INDEPENDENT EXPERT BUILDING DEFECTS REPORT

283–289 Blaxland Road, Ryde NSW

Strata Plan: SP 92028

Purpose: Assessment of alleged defective and incomplete building work

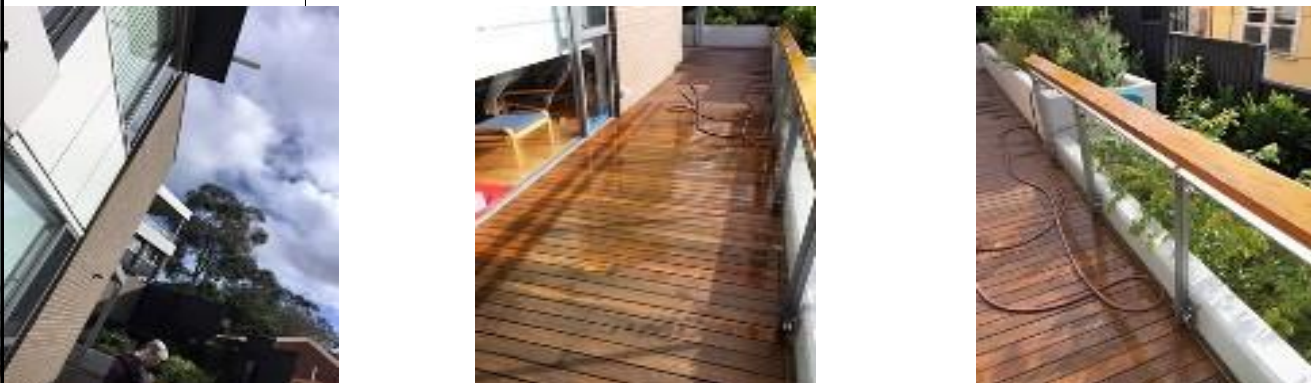
10. Concrete topping of the Southern external concrete stairs

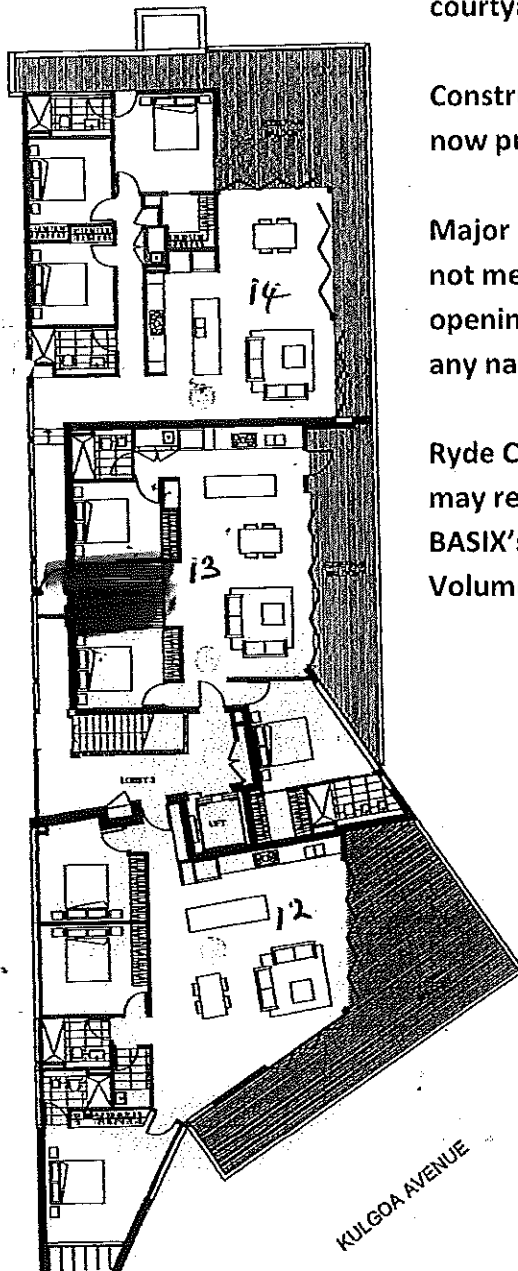
aware after settlement in September 2015 that the builders - TCQ organised changes to the approved Open Courtyard within Lot 13.

The Owners Corporation were not installed until the first AGM October 2015. At no time has the OC been informed or supplied of plans setting out why this roof was constructed over the open courtyard in Unit 13.

Construction of a roof over this open courtyard now puts it under the governance of the OC.

Major concerns are raised as the alterations do not meet the Building Code of Australia. Bedrooms opening onto this now enclosed area are without any natural light or ventilation.

There are various ways to remedy the current situation which could involve applying for a section 96 application (modification of consent) as well as a building certificate application for Council to consider allowing the existing works to remain, however in this current form this is unlikely to be supported.

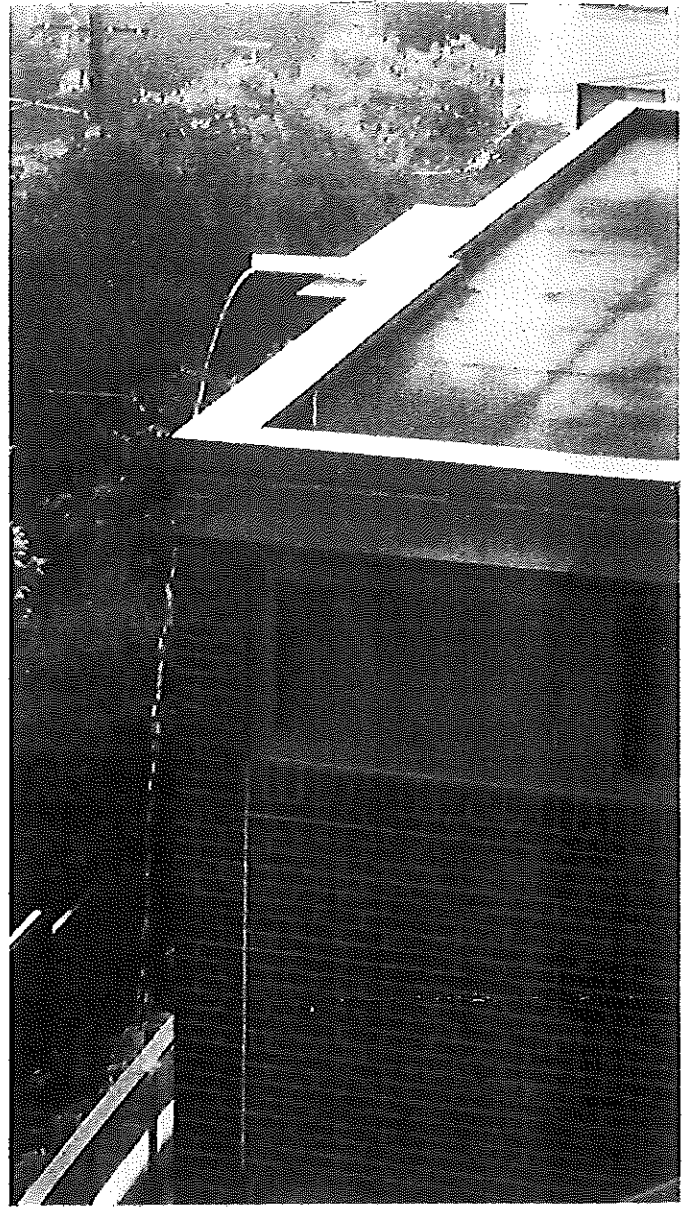
Temporary pipe put in by TCQ over (MAY 2016)
a month ago, creates a waterfall effect,
onto the rail and deck of Unit 1 and the
sound created by the pounding water is
unacceptable and also damaging the rail
and deck.

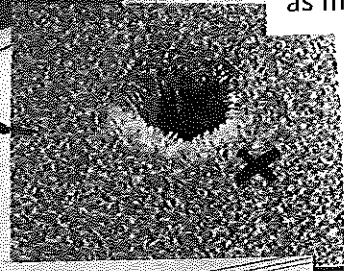
Position of Gap hole in side wall

Position where water pools
no down pipe to stop water
spilling onto Balcony of Unit 1

Enlarged view of drain hole
as marked X in picture 34

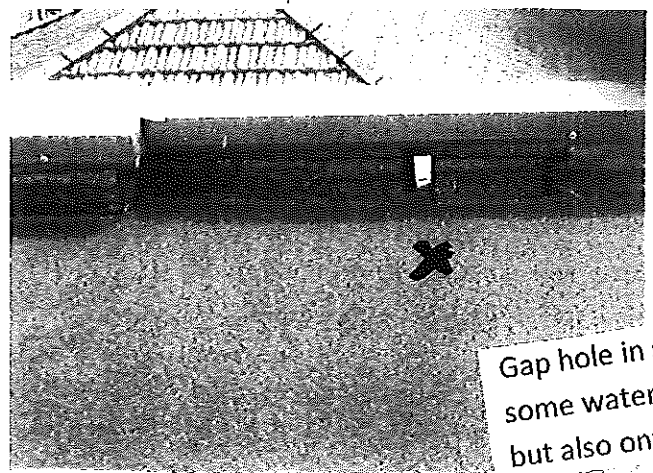
Drain nearer to Unit 11,
No water appears to enter

Gap hole in side wall
some water spills through
but also onto Deck of Unit 1
